professional
products division**SERVICE BULLETIN**

Date: May 18, 1959
Model: 300
Bulletin No: Index
Page No: 1

TYPICAL SIGNAL VOLTAGES, MODEL 300 ELECTRONICS CATALOG NUMBER 559

RECORD AMPLIFIER RESPONSE
7 1/2 INCHES PER SECOND (NAB)

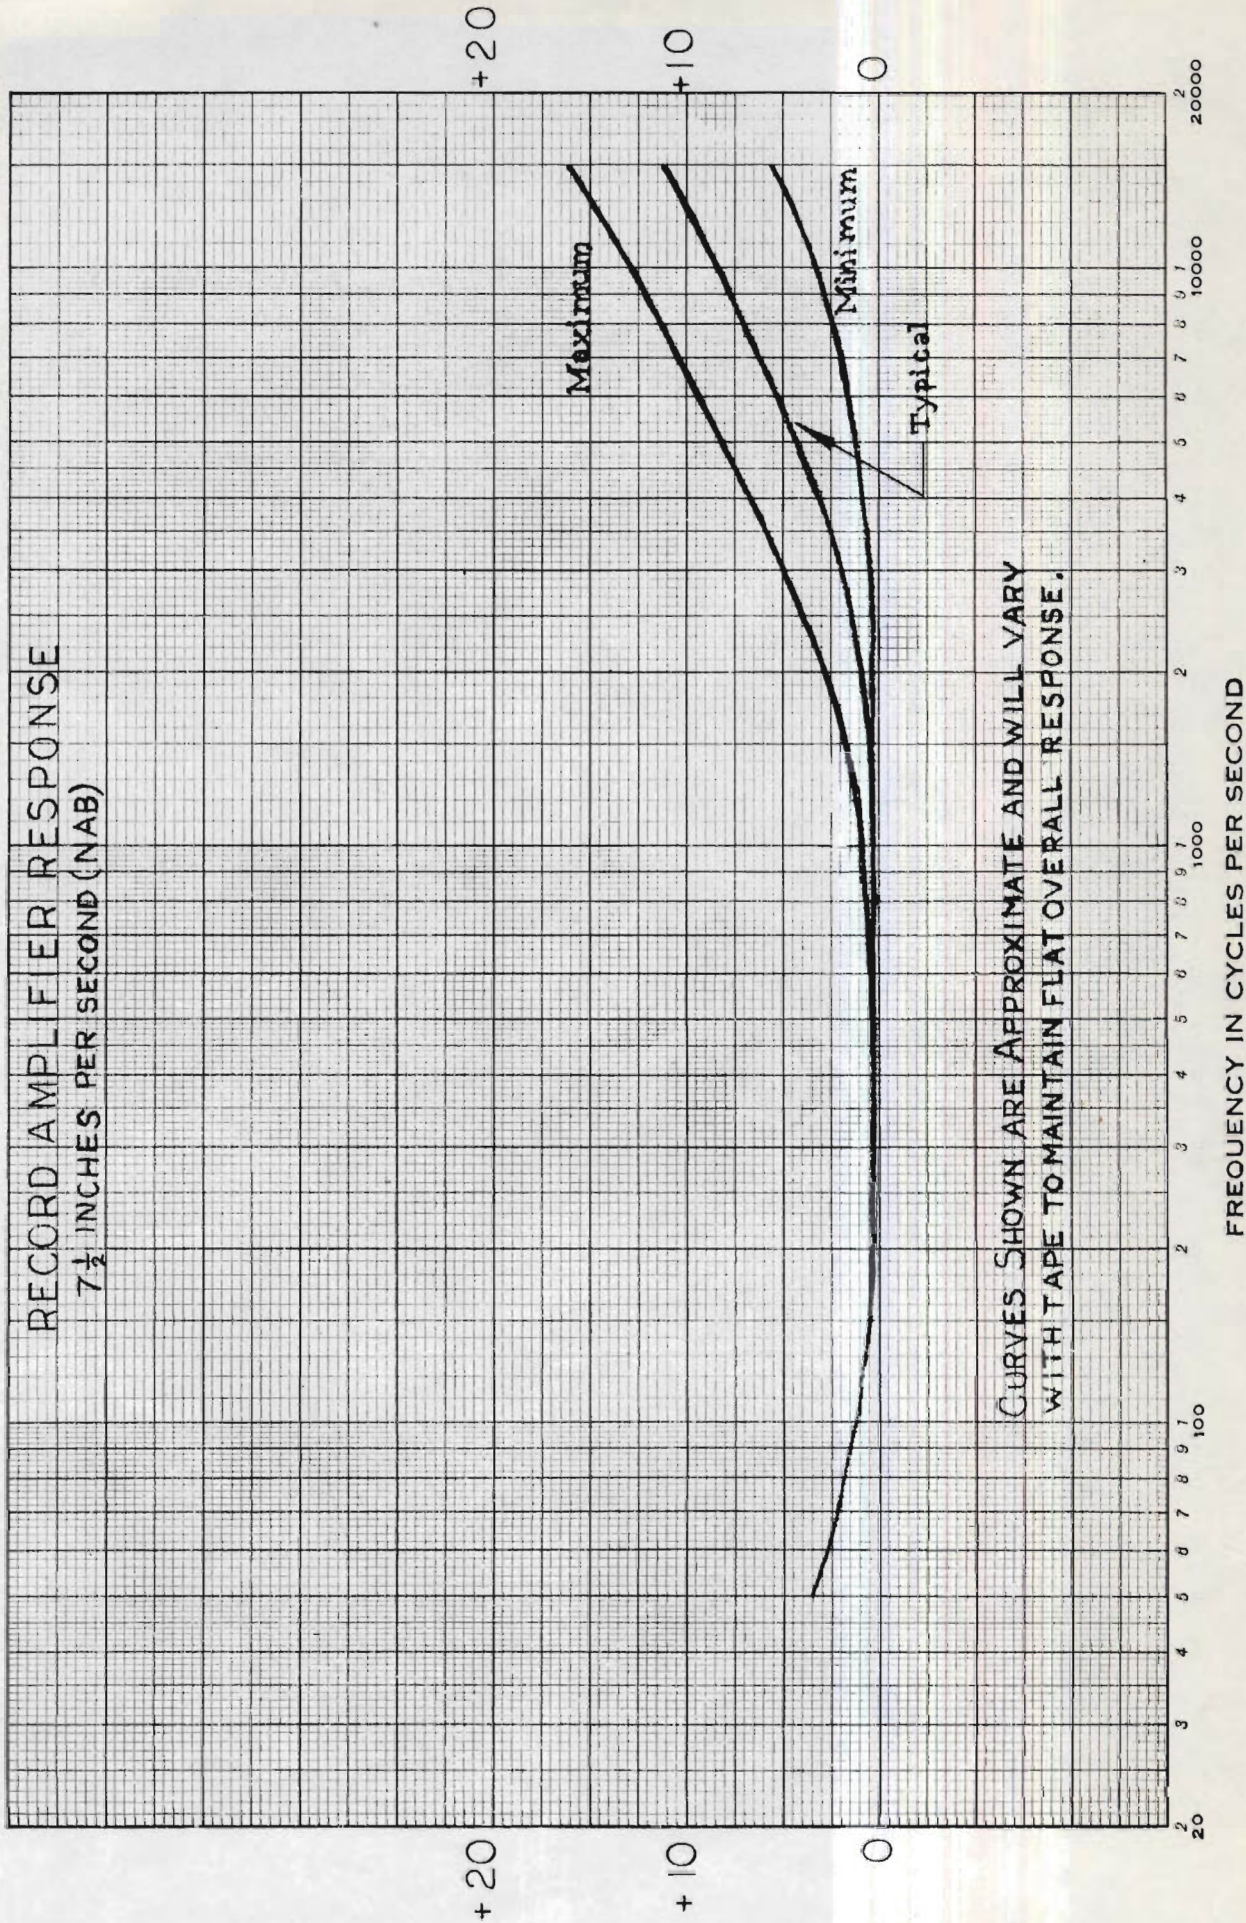
CHANGE IN RECORD CURVES - MODIFICATION OF CATALOG NUMBER 559 ELECTRONICS (MONAURAL TYPE)

Loosen the two screws holding the long terminal board to the chassis. Remove R105 (1 meg) resistor located on the relay side of the terminal board and replace it with a 470K, 1 watt, 5% resistor (Ampex number 041-124). Replace the terminal board on the amplifier chassis. Set the amplifier to the new record curves attached using the test procedure given in the maintenance manual. After installing the amplifier in the recorder, a complete response check of the machine should be made with the same kind of tape which will be used during recording. Some trimming of the record equalization may be required depending upon the tape used.

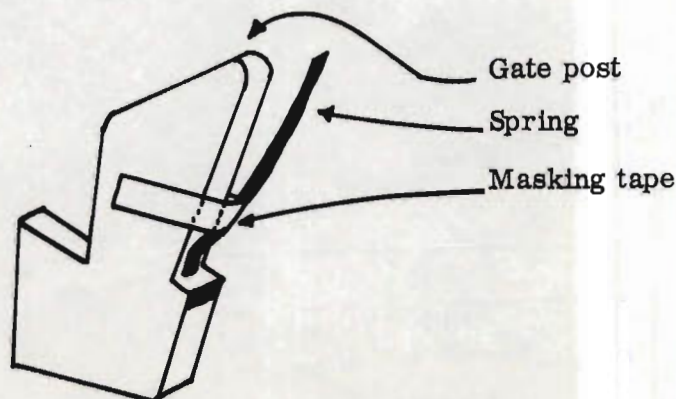
Should it be necessary to replace the 438-1 gate springs, the following method has proven to be the most practical:

1. Pull the drive pins at each end of the gate and remove the gate.
2. The springs are placed in the gate post with the crimped section in the slot as shown. They should be held in place with a small piece of masking tape. Be careful to keep the springs as straight as possible with reference to the gate post.
3. Push the gate assembly into place, in open position and insert the springs in the stop post slots during the process.
4. Insert the drive pins in the gate ends, leaving about 1/16" of the drive pins extending. Remove the masking tape.

FIG. 1

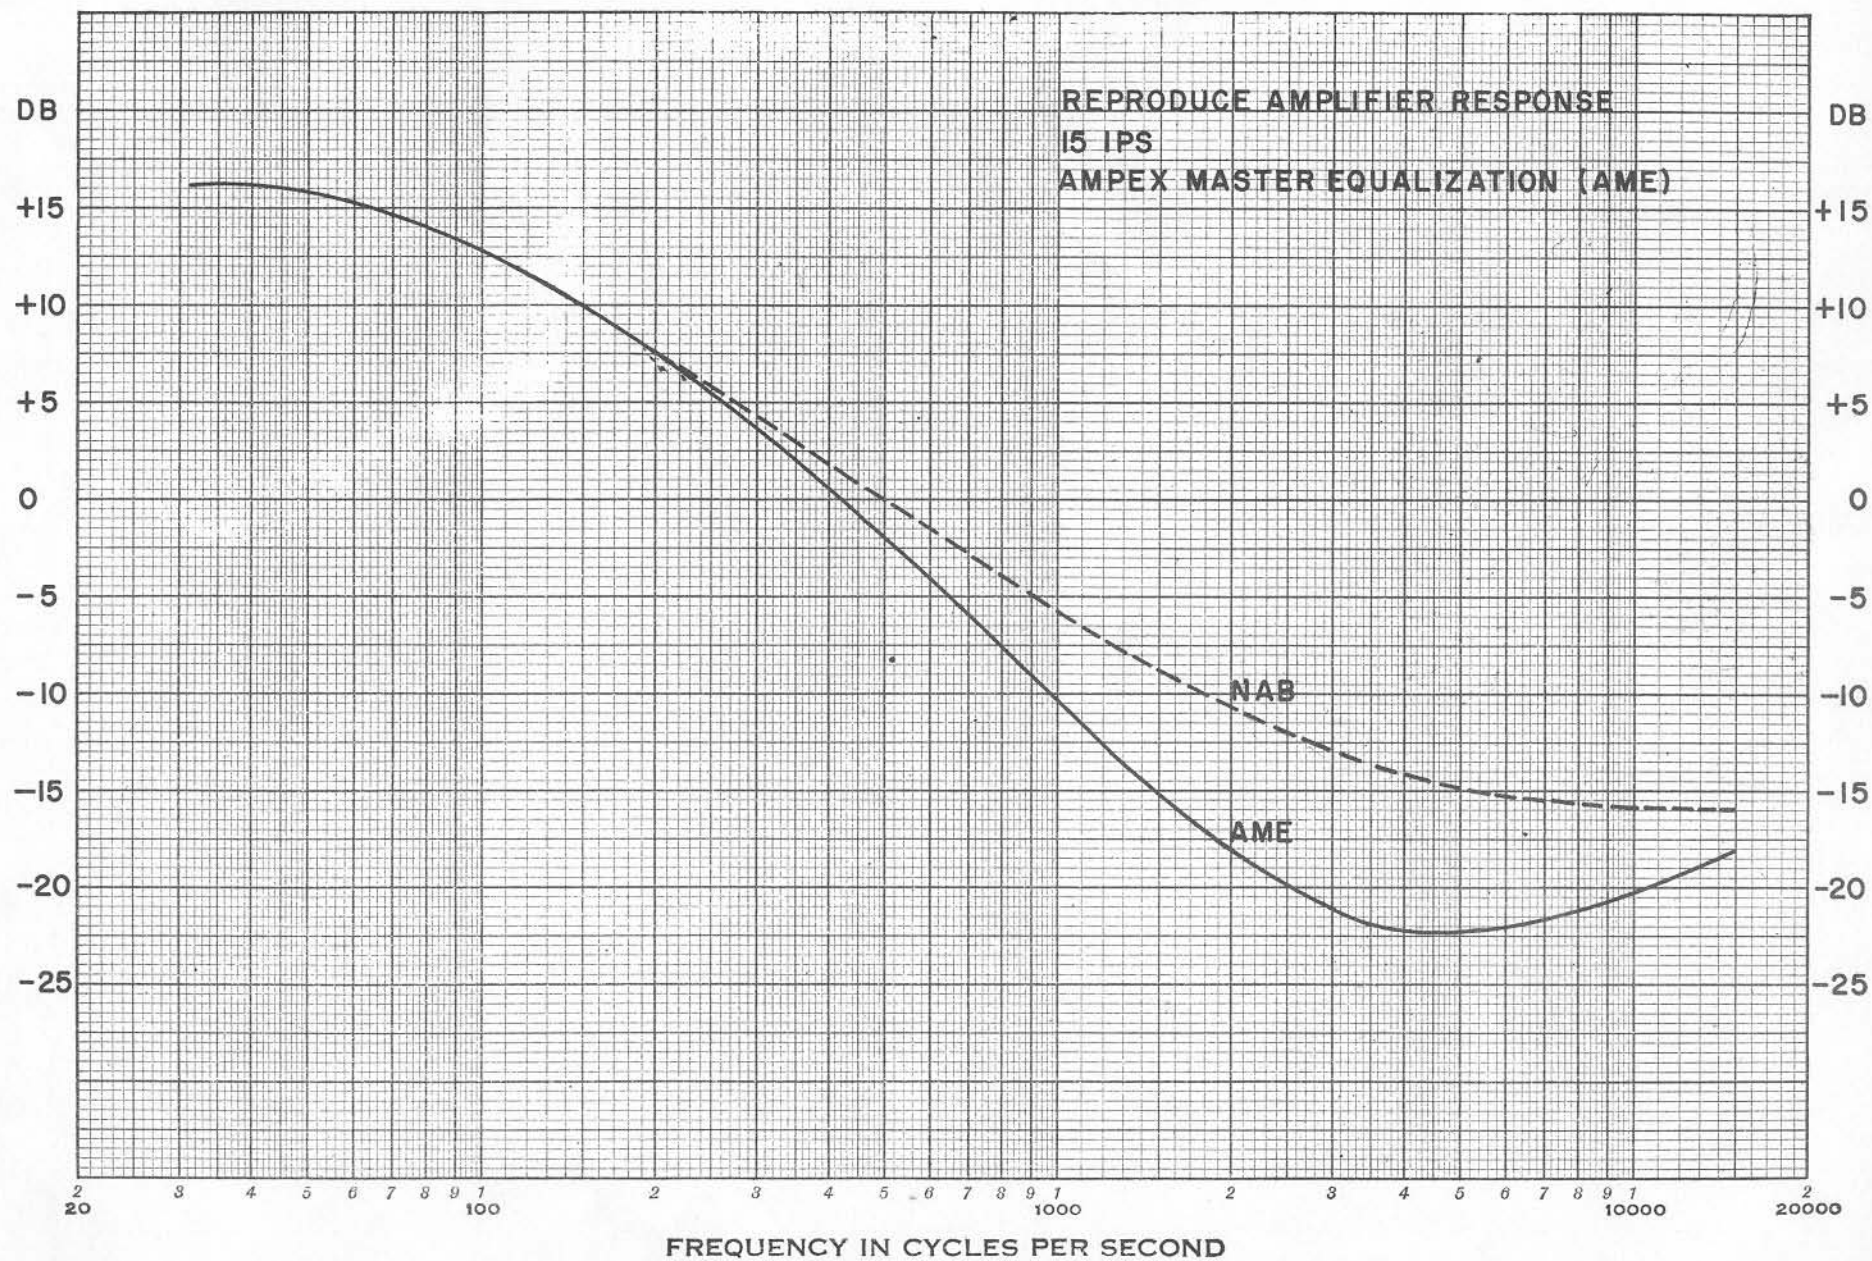
The playback curve (Fig. 1) differs from the NAB curve by a depression of the response by about 8 db in the region from 2000 to 6000 cycles. The AME record curve (Fig. 2) incorporates an increase in response in this same area, such that the overall response of the recording system is flat from record input to playback output.

A companion change should be made in the playback circuit to yield the response shown in (Fig. 1). However, this change is complex. In the interests of simplicity, we have developed an external "black box" which is to be inserted in the output line immediately following the playback amplifier output. This is shown in (Fig. 4). Note that this circuit does not provide flat overall response when monitoring the input signal (Meter and Output Switch in the RECORD LEVEL position), and that the meter will read an equalized, rather than true, response on the playback of an AME-recorded tape. The equalized meter response does provide, however, a true indication of the signal actually recorded on the tape. The insertion loss of the network shown in (Fig. 4), using the specified inductors is 1/2 db. Use of other inductors may result in more or less insertion loss.

MODEL 350
AMPLIFIER MODIFICATION
(FOR AME CURVE)

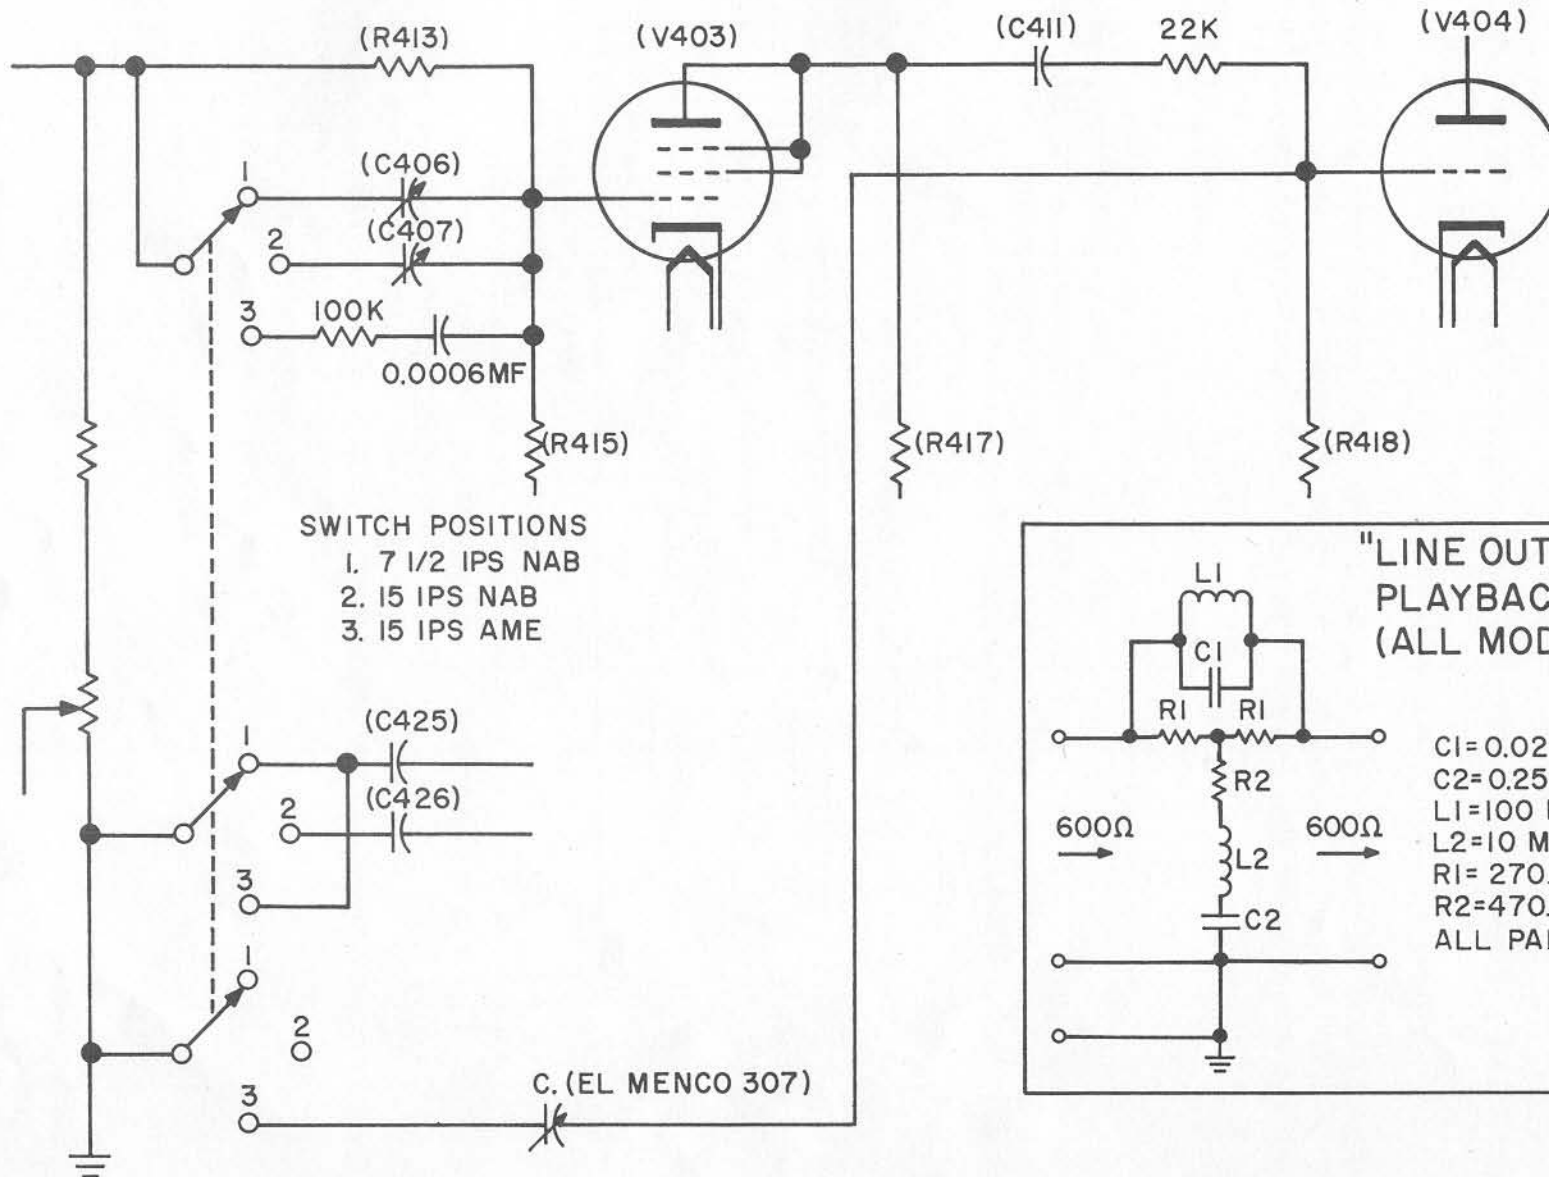
The record circuit changes to Model 350 equipment is shown in (Fig. 3). A three position switch is used in place of the present two position equalization switch. This allows the new equalization to be added without losing the present NAB equalization. Obviously, the two position switch might be rewired if one were to sacrifice flexibility. Control C. should be adjusted to yield the response curve shown in (Fig. 2).

FIG. 4

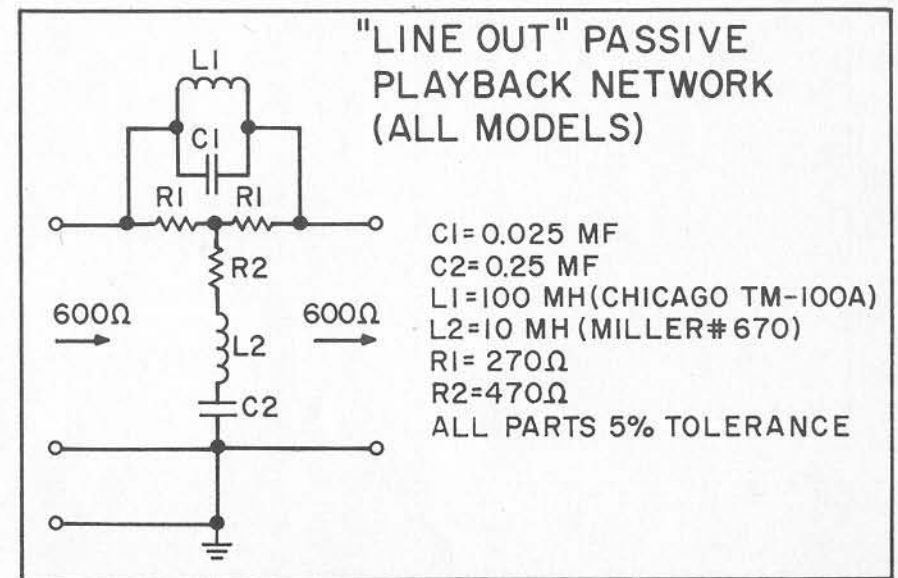
To align the equipment to the new AME curves, it is desirable to use a standard alignment tape. The Ampex Standard Alignment Tape, Cat. No. 4494 or Cat. No. 50483, will play back through the passive output network (Fig. 4) with the characteristic shown in the special response curve of (Fig. 5).
